SUBJECT: Investigation Radiological Survey and Sampling Results in Response To Request for
Additional Information Concerning Application for Amendment to License STC-133
Dated March 3, 2010, Control No. 143447

**FOLLOW UP INVESTIGATION RADIATION SURVEYS AND
SAMPLING RESULTS**

NEW HAVEN DEPOT

NEW HAVEN, INDIANA

Figure 7: SU 8-1, 8-2 and 8-3 Biased Surface Activity Measurement Locations

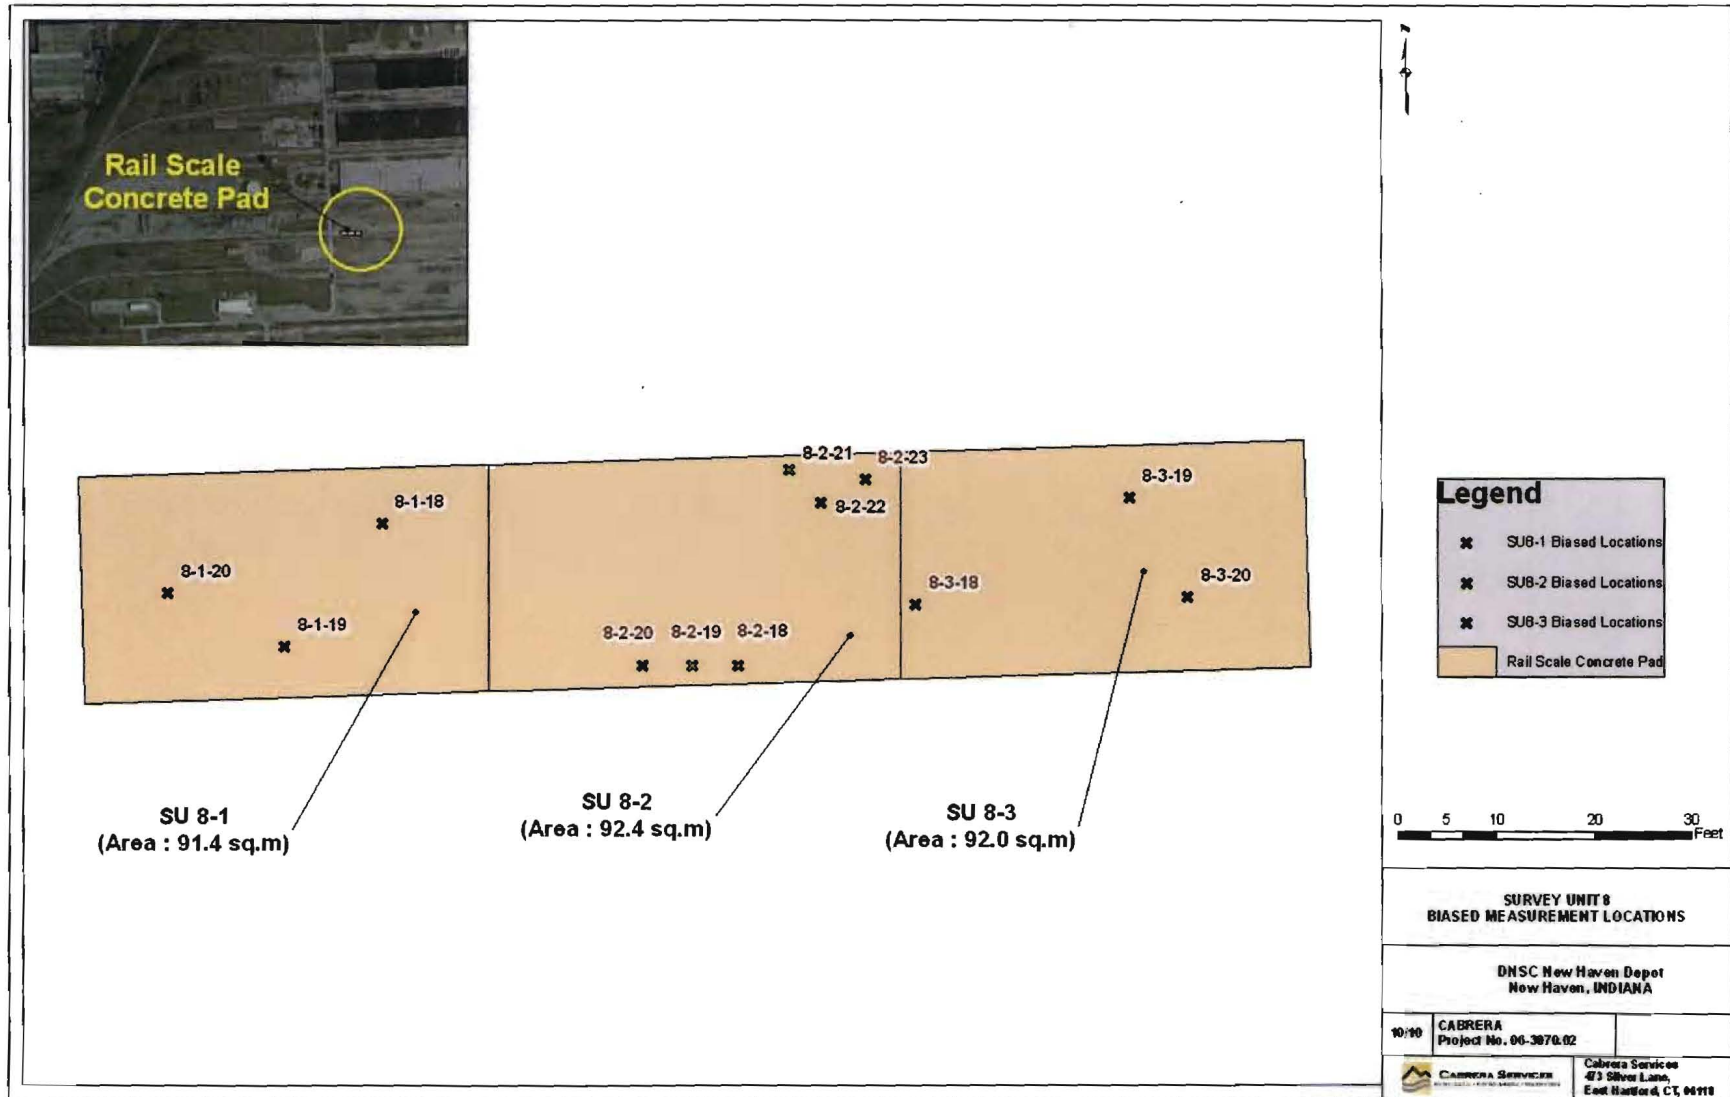
SU 8 is the concrete rail scale, a Class 2 Survey Unit, with an area of 276 m². Although five of the six surface activity measurements obtained during the Confirmatory Survey were below the DCGL_w of 100 dpm/100 cm², the Report states that elevated alpha surface activity in excess of the DCGL_w was found on a crack in the concrete, resulting in incorrect designation of the Survey Unit as Class 2.

The locations of biased direct surface alpha activity measurements are provided in Figure 7 and the results provided in Table 14.

Surface alpha activity results presented in Tables 11, 12, 13 and 14 do not identify locations in excess of the surface activity DCGL_w.
